LaserBase MF5730
LaserBase MF5750
LaserBase MF5770

MF5650-016
(SH-T01-0LD-10043-01)

Deletion of insulation sheet under the SCNT board assembly

P-1 SCNT BOARD ASSEMBLY
[1] Insulating sheet to be removed

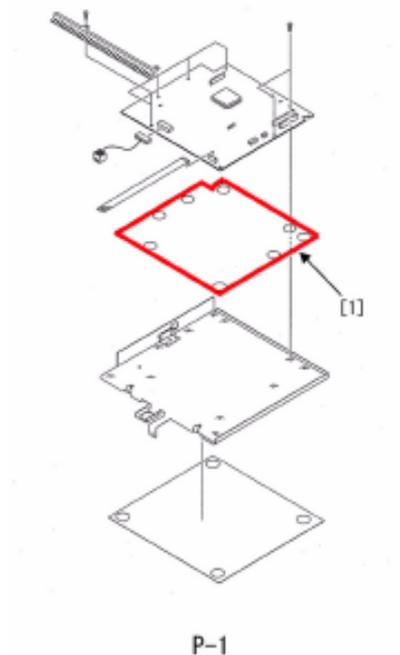
Due to the productivity, insulating sheet [1] under SCNT board assembly is removed.

There would be no problem even the insulating sheet is removed because the length of components under the SCNT board assembly, and a bend of SCNT board assembly and sheet metal have been already checked for the production.
